1992 Corvette ZR-1: Service Bulletin: Lack of Wide Open Throttle Engine Underpower

Subject: LACK OF WOT-LOW ENGINE POWER REVISED CABLE ADJUSTMENT PROC.

Model and Year: 1992 CORVETTE ZR-1 WITH 5.7L ENGINE AND MANUAL TRANSMISSION

Bulletin Number: 92-214A-7B - (07/01/1992)

THROTTLE BODY AND ACCELERATOR PEDAL CABLE ADJUSTER

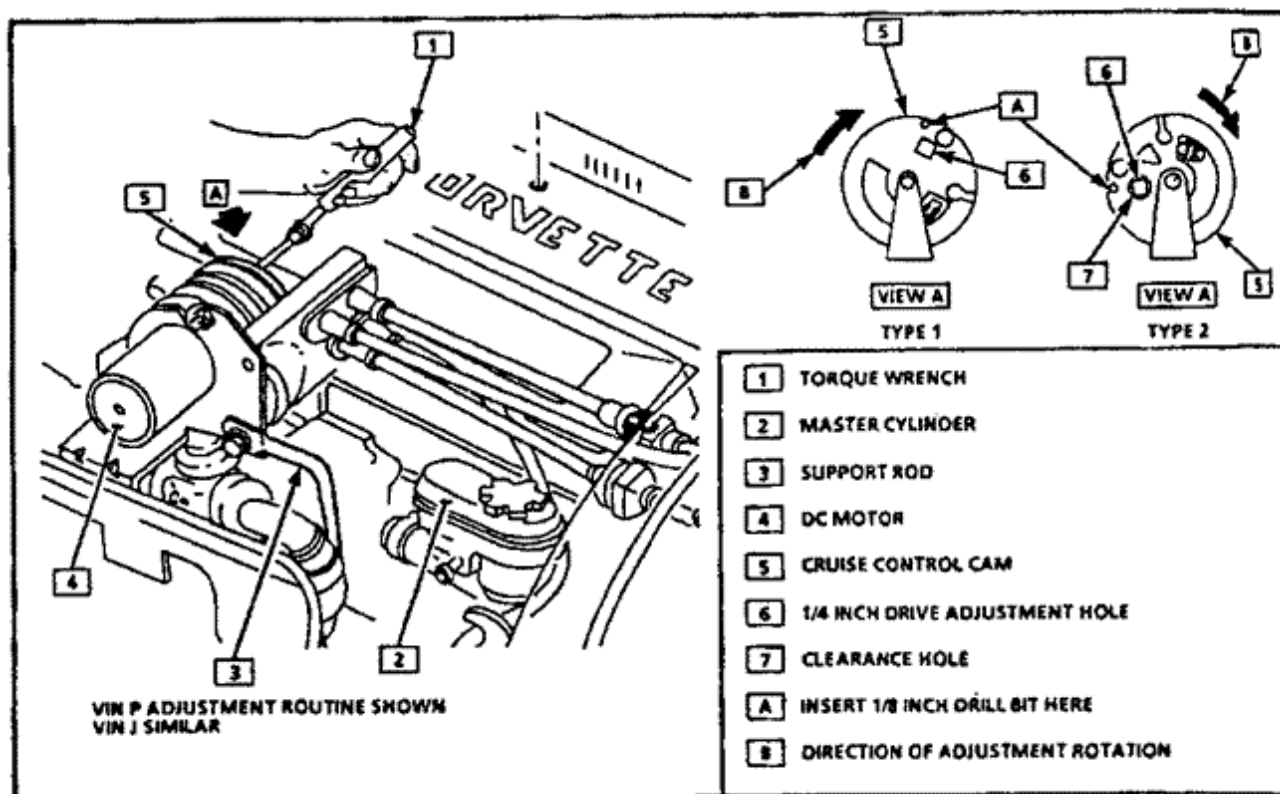
Adjustment procedures revised at assembly plant.

1. Remove adjuster cam assembly splash cover, foam shield, and cable cam cover.
2. Disconnect cruise control cable from the cruise control servo.
3. Depress reset button on the throttle control cable and fully extend cable sheaths (see figure).
4. Insert a 1/8 inch drill bit into adjuster assembly alignment hole (see figure, item A).

5. Insert a torque wrench with a 1/4 inch drive extension into square hole on the cruise control cam (type 1) or through the cruise control cam into the accelerator cam (type 2) (see figure, item 6).
6. Turn the torque wrench clockwise until obtaining a torque of 4 N.m (35 lbs. in.). During adjustment, several clicks of the adjuster should be heard. If not, repeat step 3.
7. Remove the torque wrench AND drill bit.

10. Using a Tech 1 with an 88-92 Brake System Cartridge, check throttle angle percentage by depressing the accelerator pedal. When the pedal is fully depressed, throttle opening should be 100 percent. When the accelerator pedal is released, throttle opening should return to 0 percent. If proper results are not obtained, check cables for kinks or damage, and repeat adjustment procedures.
